AMENDMENTS TO THE DRAWINGS

REMARKS

WO 2004/051165

PCT/KR2002/002272

FIG. 75

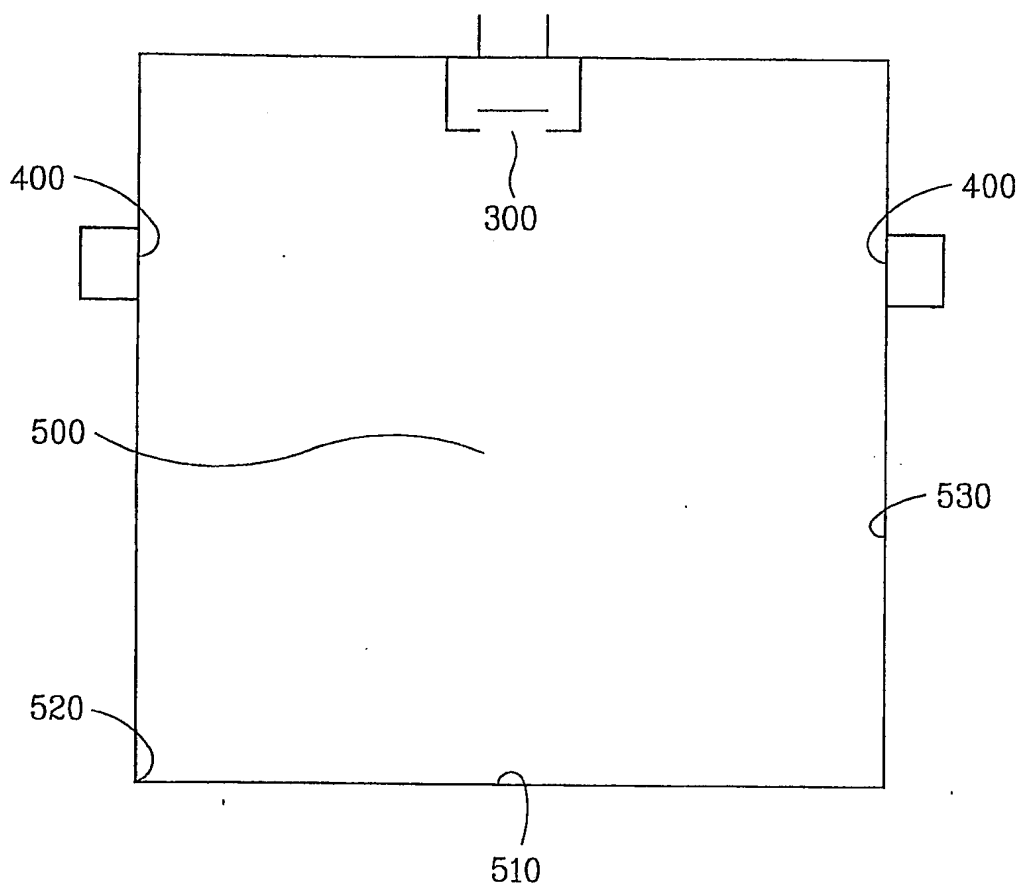
The attached sheets of drawings includes changes to Figures 5A, 5B, 6A, 6B and 7 in light of the objection noted in the Office Action.

The Office Action objects to Figures 5A, 5B, 6A and 6B as being unclear copies. It is respectfully noted Figures 5A, 5B, 6A and 6B have been deleted from the present application. Original Figure 7 has also been amended to be Figure 5. The Specification has also been appropriately updated. Accordingly, it is respectfully requested the objection to the drawings be withdrawn.
